CRIME IMPACT STATEMENT

Plot F, Great Jackson Street Framework Area

FOR: Renaker Build Limited

REFERENCE: 2021/0264/CIS/01

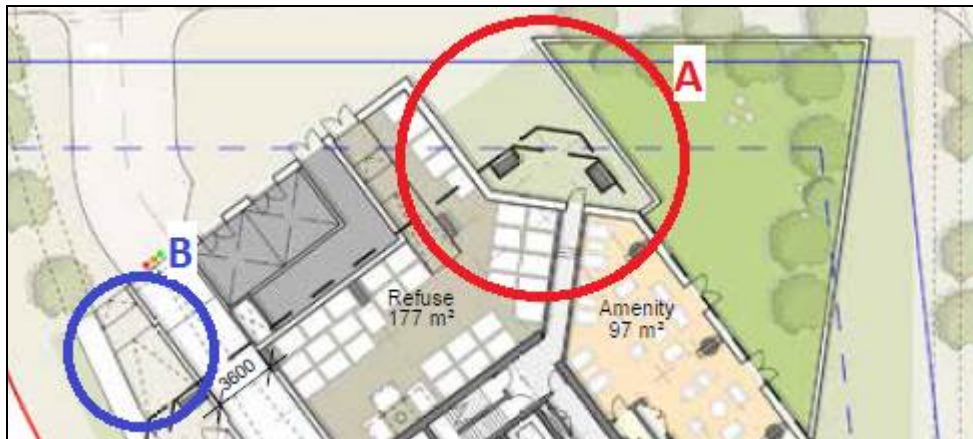
- 3.3.1 The two areas circled above (Block F1) are of concern for the following reasons and measures should be incorporated to mitigate the potential risk.

- A. This area between the building and the residents garden could potentially be a concealed area / blind spot and allow facilitate, or generate antisocial and criminal behaviour, such as loitering, alcohol/drug consumption, or target the door in this area without being easily seen. Consideration should be given to incorporating some visually permeable screening to the resident's garden to allow this area to be viewed by those using the garden space. This area should be illuminated to a high standard, particularly the area under the building above, and be covered by CCTV. Any security patrols of the development should cover this area.

- B. Consideration should be given to ensure that this area is not obscured from view and become an area concealed from view that could generate antisocial behaviour to the detriment of residents and staff.
